HOLDOVER

CP INVESTMENT SUBDIVISION, RESUBDIVISION OF LOT 2, RESUBDIVISION OF LOT 2B

Revised for the July 7, 2005 meeting:

DETAIL SITE PLAN

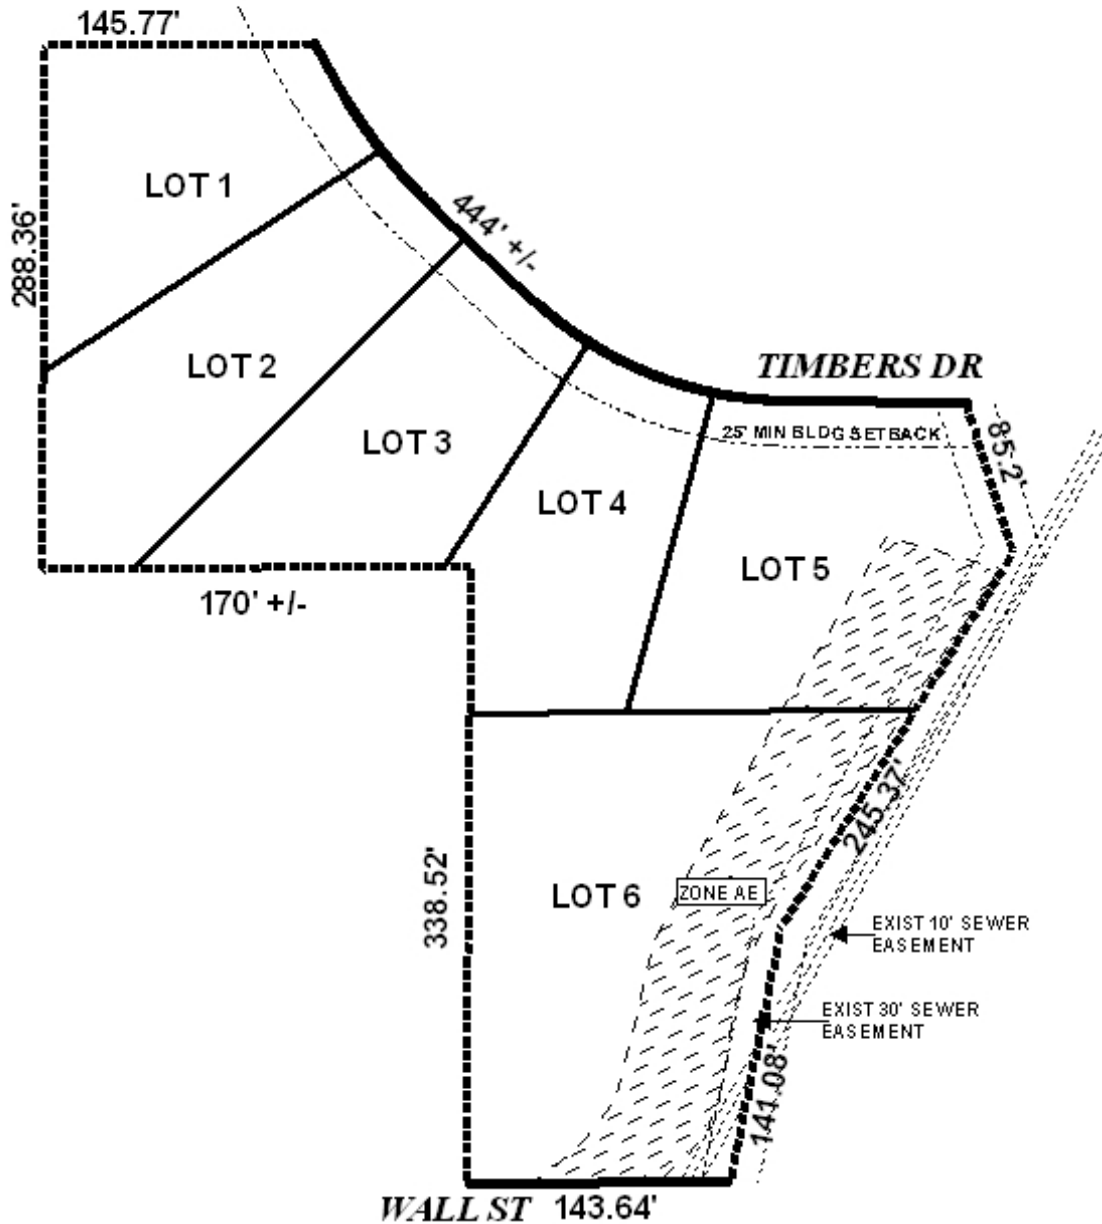
Engineering Comments: Stormwater detention is required for this development and should be constructed via the Land Disturbance permitting process prior to submittal of the final plat. The common area for stormwater detention should be shown on the plat. Engineering will require dedication of a drainage easement to include the AE Flood zone plus 10 feet along the west side of the flood zone. Must comply with all stormwater and flood control ordinances. Any work performed in the right of way will require a right of way permit.

Traffic Engineering Comments: Driveway number, sizes, location and design to be approved by Traffic Engineering and conform to AASHTO standards.

The site fronts upon two streets: Timbers Drive to the north and Wall Street to the south. Both streets are minor streets, and each meet minimum right-of-way width requirements. Timbers Drive, however, primarily serves a residential development. As the subdivision site is zoned B-1, Buffer Business, access management for Timbers Drive is a concern. In order to minimize the impact of the proposed commercial subdivision, it is recommended that curb-cuts onto Timbers Drive be shared as follows: lots 1 and 2 share one curb-cut; lots 3 and 4 share one curb-cut, and; lot 5 have its own curb-cut. The size, location and design of all curb-cuts must be approved by Traffic Engineering and conform to AASHTO standards.

The eastern portion of the site is bounded by a branch of Milkhouse Creek, and wetlands associated with the creek may occur on a portion of the site. The site, additionally, appears to be partially located in the “100-year” frequency flood zone as depicted on FEMA maps, and thus may be subject to flooding. The presence of wetlands and floodplains indicate that the area may

be environmentally sensitive; therefore, the approval of all applicable federal, state and local agencies would be required prior to the issuance of any permits.

The plat is recommended for Tentative Approval subject to the following conditions: 1) placement of a note on the Final Plat stating that lots 1 and 2 share one curb-cut, lots 3 and 4 share one curb-cut, and lot 5 have its own curb-cut, with the size, location and design to be approved by Traffic Engineering and conform to AASHTO standards; 2) depiction of the stormwater detention area, the labeling of such as a common area, and the placement of a note stating that maintenance of the stormwater detention area is the responsibility of the property owners; 3) dedication to the City of a drainage easement to include the AE flood zone, plus 10-feet along the west side of the flood zone; and 4) the approval of all applicable federal, state and local agencies regarding the wetlands, floodplain and stormwater issues.

At its June 16th meeting, the Planning Commission decided to Holdover the application until July 7th to allow the applicant time to submit detailed information regarding the drainage easement on the site. As of June 30th, no additional information had been submitted.
